Docket Item #13
BAR CASE #2005-0303

BAR Meeting
March 7, 2007

ISSUE: Concept approval of two new buildings
APPLICANT: Armed Forces Benefit Association
LOCATION: 909, 901, & 919 North Washington Street
ZONE: CD/Commercial

Figure 2: Surrounding Height Relationships

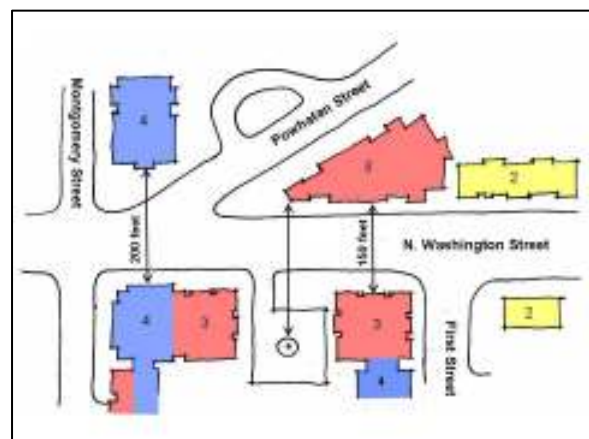
Staff is recommending that the proposal be revised from all four story buildings on Washington Street to predominantly three stories on Washington Street. The three level buildings will be more consistent with the predominant scale of this section of Washington Street and with the one and a half to two and a half story buildings and townhouses to the north. While staff is recommending that Washington Street be predominantly three stories, a portion of the proposal on Washington Street could be four levels. Staff recommends that if a four story portion of the building is proposed on Washington

Street that the taller portion should occur at the intersection of Washington and Montgomery Streets due to the width the street at this intersection. A four-level building at this location would provide an appropriate relationship between the 900 N. Washington proposed building, the American Association of Physicians Assistants (AAPA) building and this intersection. The proposal should also explore the possibility of a setback from the corner of North Washington Street and First Street to provide more green space on First Street, consistent with previous BAR recommendation.
